Sheet: /		
File: OPA858.sch		
Title:		
Size: A4	Date:	**Rev:**
KiCad E.D.A. kicad 5.1.2-f72e74a84ubuntu18.04.1		Id: 1/1

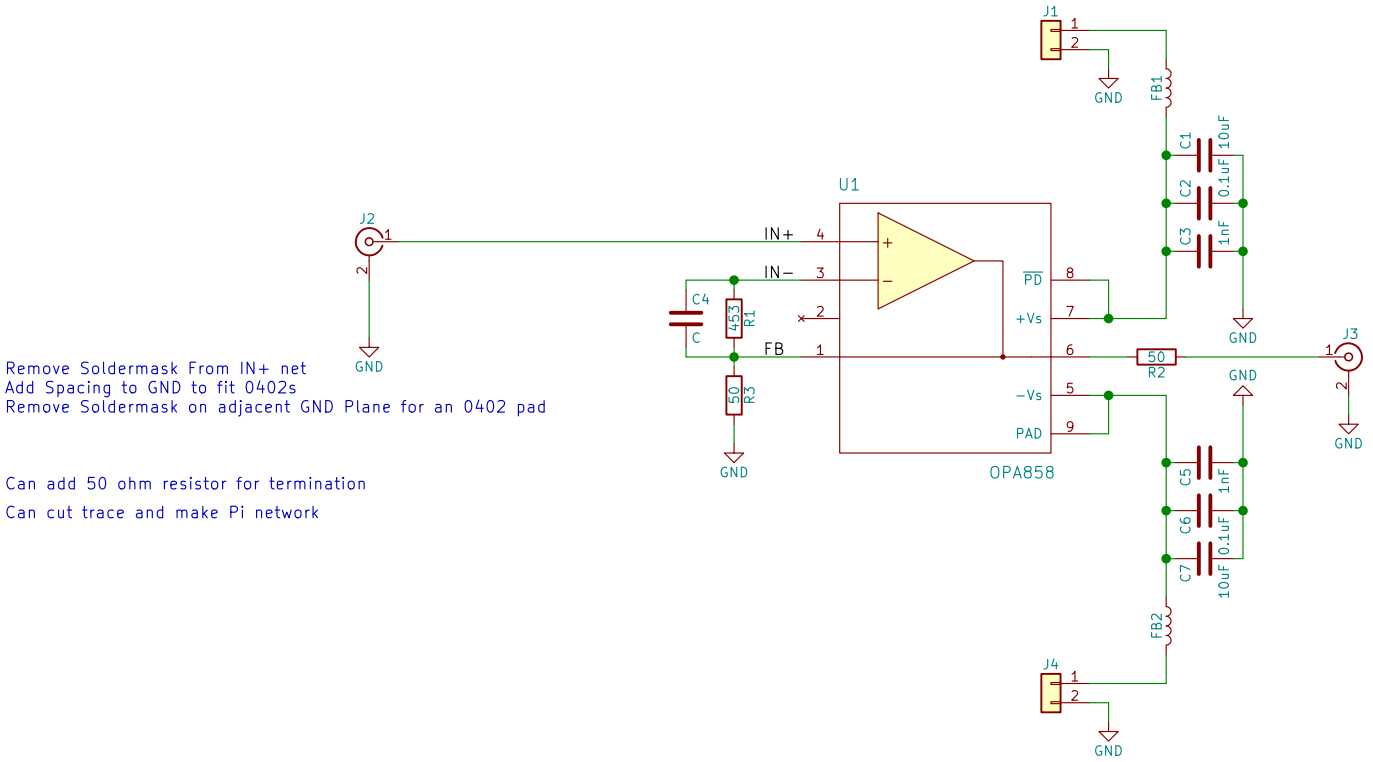
Remove Soldermask From IN+ net
Add Spacing to GND to fit 0402s
Remove Soldermask on adjacent GND Plane for an 0402 pad

Can add 50 ohm resistor for termination

Can cut trace and make Pi network
